C1980007, West Elk Mine, October Inspection Report and NOV CV-2020-001

PERMIT INFORMATION

NOTICE OF VIOLATION

Notice of Violation No.: CV-2020-001

Figure 1: Overview of subsidence at South Prong Creek

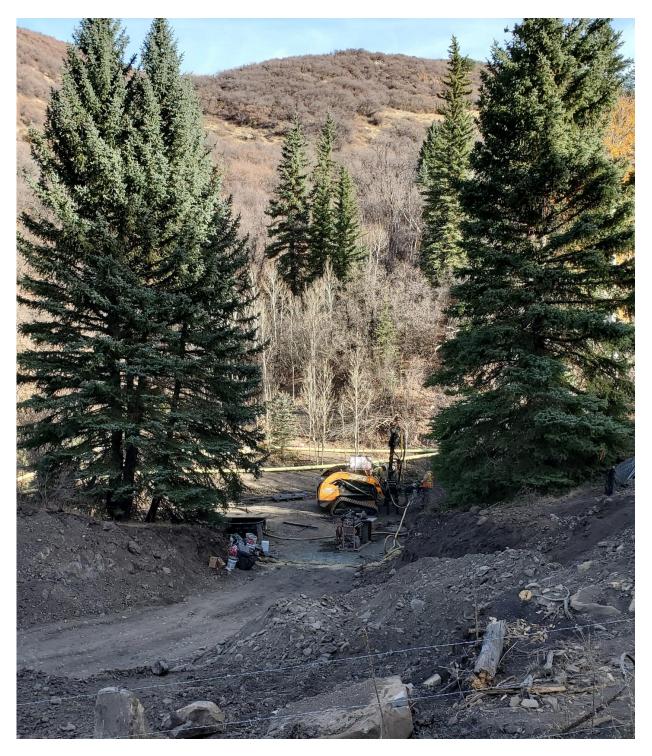
MCC had previously notified the Division of subsidence that had occurred during the afternoon of Monday October 13th, as a result of development mining under South Prong Creek. A hole, approximately 40' across, had opened up on the surface, just upstream of the confluence with the North Fork of South Prong Creek, causing water from the creek to flow into the mine workings. MCC staff had responded immediately, setting up pumps and a temporary diversion during the night. Stream flow was initially estimated at 100 gallons per minute (0.22 cfs), and later measured at 160 gallons per minute (0.36 cfs). The stream flow had been successfully diverted around the subsidence hole by the morning of Tuesday October 14th.

The main focus of the inspection was the damaged area, the associated disturbance, and the ongoing repairs. At the time of the inspection the water in the creek had been directed into a lined sump, which gravity drained into a 16" pipe. The 16" pipe split into two 6" pipes, only one of which was in use. The other pipe was available to provide capacity in case of increased stream flows. A second sump had been constructed just downstream of the first, which allowed a small electric pump to be used to pump the small amount of water that ran under the lining to be pumped back up to the first sump through a hosepipe as necessary.

Topsoil had been salvaged from a borrow area adjacent to the subsidence and stockpiled. The perimeter of the disturbance had been protected with a silt fence. The topsoil stockpiles had been marked with sign posts, and protected with mulch and straw wattles. Cobbles and large boulders had been set aside. The subsided area had been filled with native material from the borrow area, compacted in 2' lifts. A 6-8" thick bentonite cap had then been made in place.
